## ATTACHMENT 1 – Council Submission

### 1. The SSDA is not in the public interest

**Map 5: Snap shot from WLEP 2012 Height of Buildings Map**

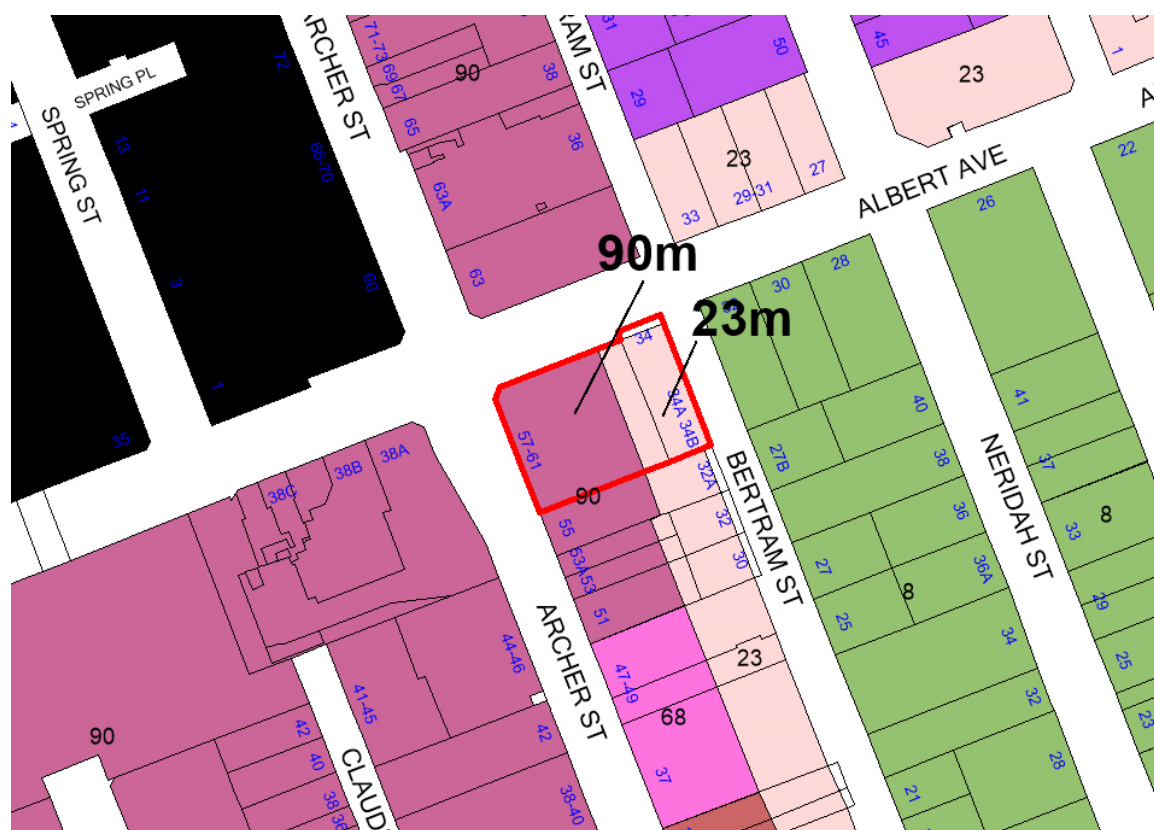
It should be noted that a low density residential conservation area is opposite the subject site in Bertram Street (the South Chatswood Conservation Area with a maximum height of 8m). While the height on the Archer Street side of the block was made at 90m, the height on the Bertram Street side was reduced to 23m. The complexity around the height on the block bounded by Albert Avenue, Bertram Street, and Archer Street (as supported by DPHI) is shown below in **Map 5: Snap shot from WLEP 2012 Height of Buildings Map**.

The point is made that Council planned for housing provision by significantly increasing height of the subject site on the Archer Street side of the block, to a height considered appropriate both in the draft CBD Strategy and subsequent review (having regard to proximity to the low density residential conservation area).

A nuanced approach to the Housing SEPP 30% bonus uplift is sought, with the proposed additional 23m height in this location considered inappropriate based on bulk and scale impacts on the CBD boundary to the adjacent low density residential conservation area, and undermines recent strategic planning and community faith in the NSW planning system. Unlike other centres, the heights in this location have recently been substantially increased (30 June 2023), indeed maximised.

**Map 6: Area in front of 34 Albert Avenue subject to dedication (however shown as part of site)**

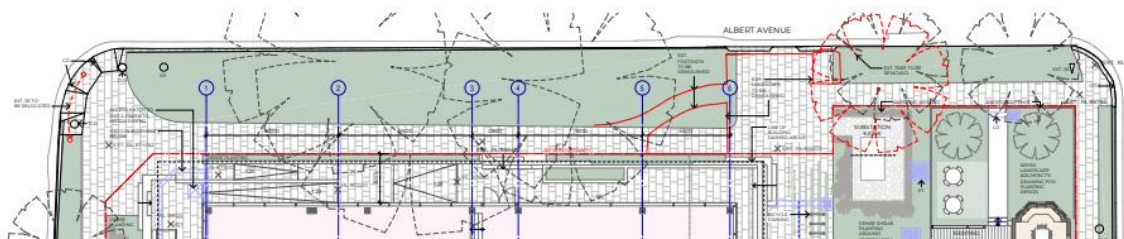
However it is noted on the architectural and landscape plans that this land is not shown as dedicated to Council, with the site boundary including this land. Moreover the proposed substation serving the subject site encroaches into this space.

The SSDA is requested to be amended to show the 3m dedication fronting 34 Albert Avenue, confirmation of the ground level areas to be subject to public rights of way, and address Council concerns regarding the pocket park and through site links (in particular on the southern boundary).

**Map 7: 'Laneway' along southern boundary and dog leg to Bertram Street**

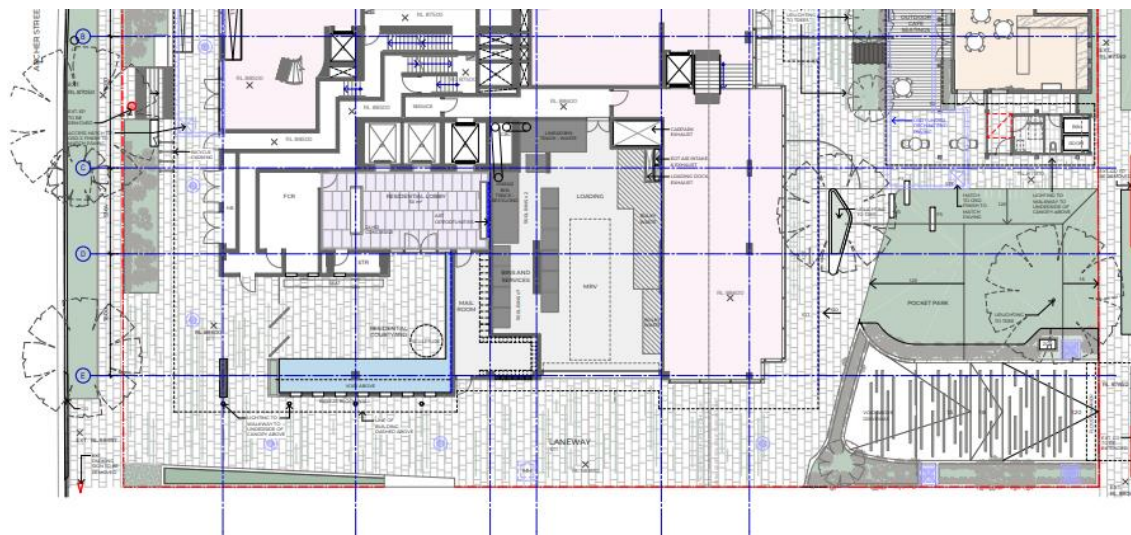
Concern is raised with how the basement vehicle entry via Bertram Street interrupts the ground level 'laneway' from Archer Street and a direct connection with Bertram Street. Clear justification is required explaining this design choice, together with mitigation measures that address Council concern that through site access is not obvious to the average pedestrian because it is not direct or clearly visible for pedestrians coming from Archer Street, Bertram Street or Albert Avenue. Mitigation measures may include pulling back the southern corner of the building as it faces Bertram Street (and the proposed basement entrance), to increase sight lines for pedestrians coming from Bertram Street and Albert Avenue. Any balustrade above the basement entrance from Bertram Street should be clear in nature to encourage visibility and be inviting to pedestrians.

The 6m 'laneway' setback to the southern boundary, and its proposed shared function, is prepared to be considered provided no loading occurs within this space. Access for HRV's via Archer Street and ground level loading, is prepared to be considered in this instance, however loading / unloading is to occur in the loading dock within the building. Design is to accommodate sufficient turning circles for HRV to access and exit the internal loading

dock, and splays are to be provided to enhance sight lines for the public accessible 'laneway.' HRV loading here is to be managed within suitable times of the day. Any other vehicle access, including loading for smaller vehicles is to be via Bertram Street. Measures to ensure the integrity of this arrangement should be conditioned in any approval. Loading is further discussed below in 8. b) Engineering comments and 8. c) Waste comments.
